South Texas Project Electric Generating Station P.O. Box 289 Wadsworth, Texas 77483

January 19, 2010
NOC-AE-10002506
10CFR50.36
STI: 32599116

South Texas Project
Unit 1
Docket No. STN 50-498
Unit 1 Cycle 16 Core Operating Limits Report

Revision 2

Control Rod Insertion Limits* versus Power Level

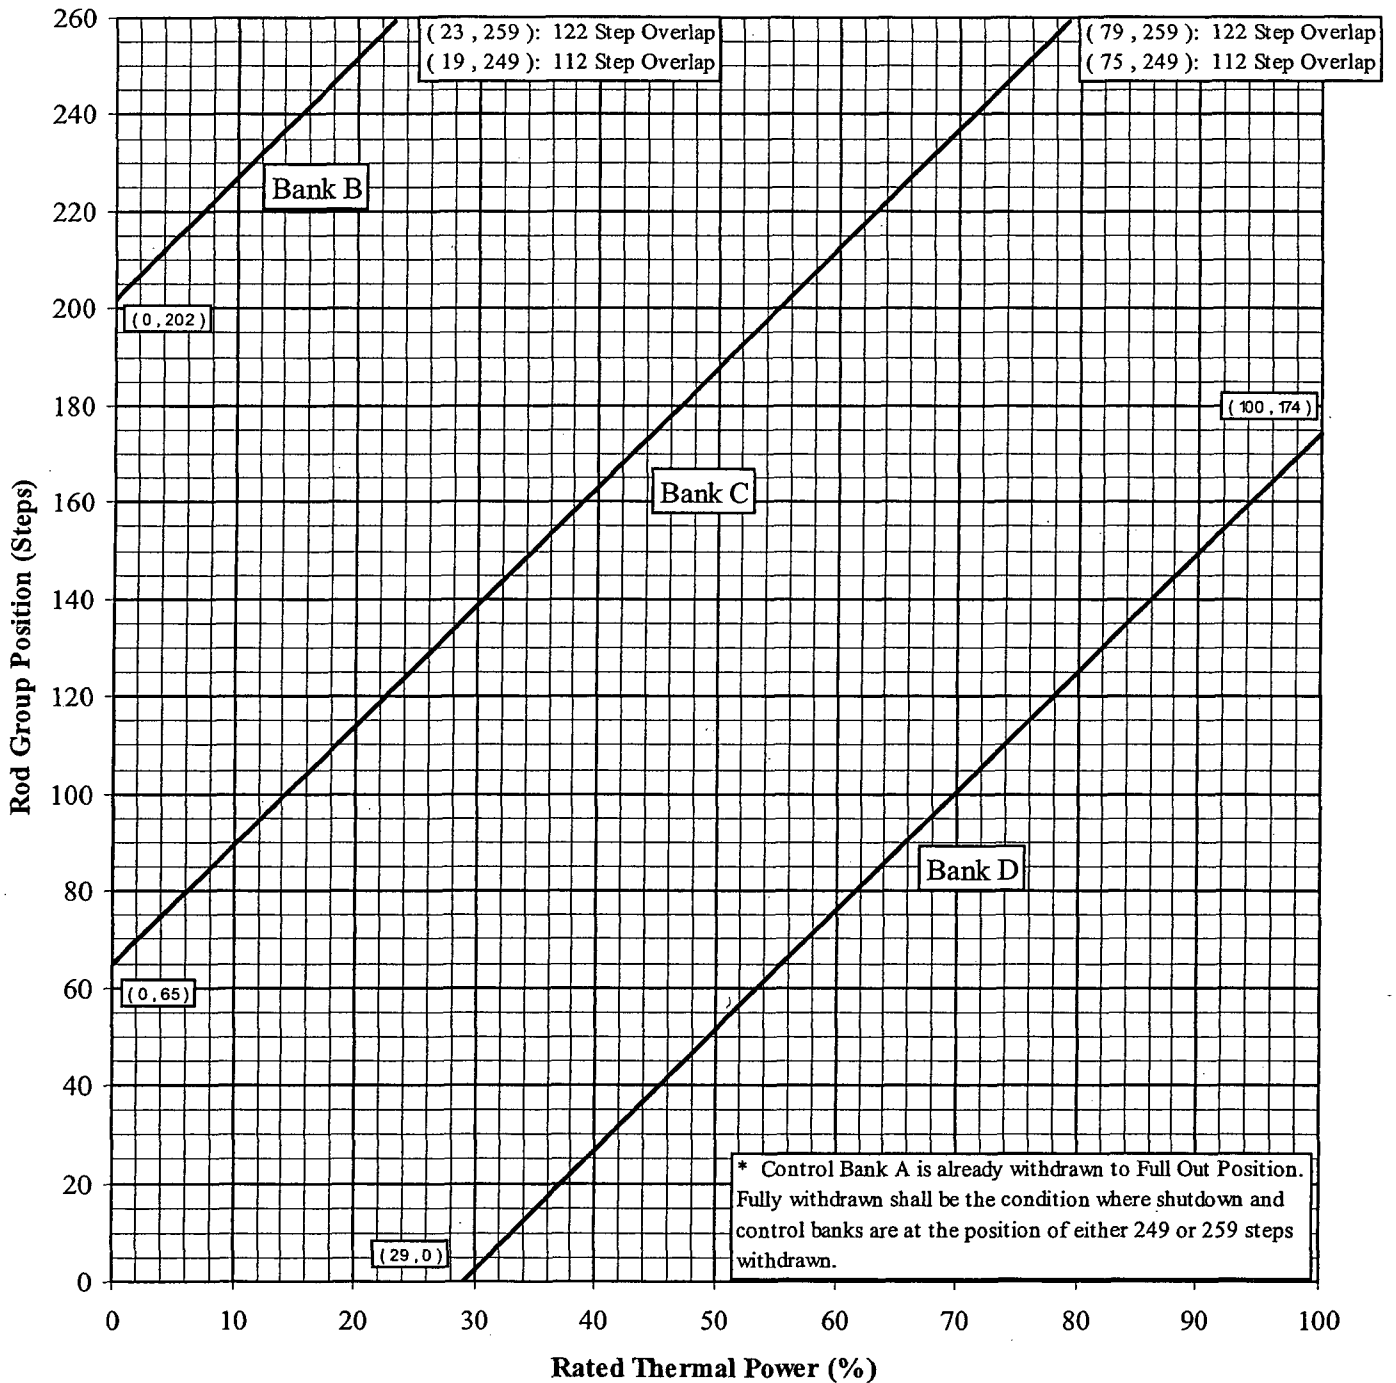
In accordance with Technical Specification 6.9.1.6.d, STP Nuclear Operating Company submits the attached Revision 2 to the Core Operating Limits Report for Unit 1 Cycle 16. The report reflects a change in the control rod full out position from 259 steps to either 249 or 259 steps.

- 2.5.1 All banks shall have the same Full Out Position (FOP) of either 249 or 259 steps withdrawn.
- 2.5.2 The Control Banks shall be limited in physical insertion as specified in Figure 5.
- 2.5.3 Individual Shutdown bank rods are fully withdrawn when the Bank Demand Indication is at the FOP and the Rod Group Height Limiting Condition for Operation is satisfied (T.S. 3.1.3.1).
